CAPRICORN MUNICIPAL DEVELOPMENT GUIDELINES

2026 MEETING 4 MINUTES

Venue: Teams
Date and Time: 25th June 2026 at 11am

M26.04.03

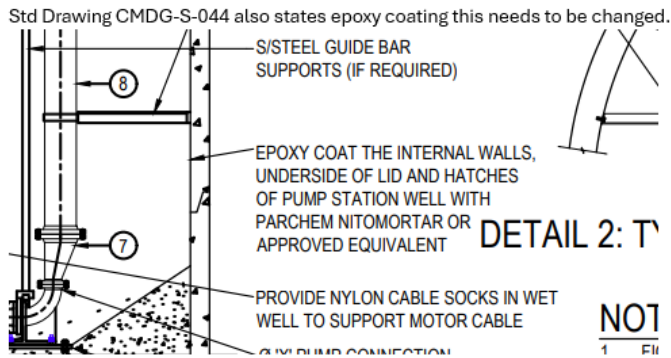
Sewer manholes and SPS coatings - Item not discussed at M2026.04.

Request from LSC to remove the use of epoxy for lining of SPS or manholes.

I wish to request for the D12 Sewerage Design - Table D12.09.08 to be updated to be;
Livingstone Shire - *Fabricated polyethylene type or approved equivalent with integral benching, bottom, top, access neck and pipe stubs.*

Chemical Resistant Barriers (Vinyl Ester, Poly, PVC) may be used for refurbishing existing concrete access chambers only.

Are you able to provide an explanation and summary that I can share with the committee? It appears that epoxy coatings are the industry standard for lining of manholes, noting that the proposed coatings such as vinyl ester, while providing higher levels of protection are significantly more expensive and potentially not required for all cases. Given the increased cost and application difficulty with vinyl ester coatings vs epoxy is there a good justification for use in discharge manholes (and the other nearby downstream manholes)?

Does LSC have some examples of failed epoxy coatings in standard operational scenarios? I also note that if possible we shouldn't be using higher than necessary standards for new infrastructure to alleviate issues that council is experiencing with existing infrastructure operations, e.g. higher than normal levels of H₂S from septicity. This is something that has come up before and been discussed at meetings, examples are increasing minimum drainage pipe sizes, minimum watermain sizes, minimum pressure at water meters to name a few. The agreement has generally been not to implement blanket changes.

Notwithstanding the above, it should be noted that there is a discrepancy between drawing CMDG-S-061 and clause D12.20.10/ Table D12.09.08 in D12. However the specification overrides the drawings so currently epoxy coatings are technically not approved for new SPS wet wells.

What has been proposed (and is currently in D12) does not seem to cover a standard in-situ concrete SPS, pre-cast concrete or some other proprietary products, as the only allowable option for new infrastructure is a prefabricated polyethylene chamber? Can you confirm the intent of this?

In addition to the above, polypropylene and polyvinyl chloride chambers are approved for use and I suggest these will also provide adequate levels of protection and should be included in table D12.09.08.
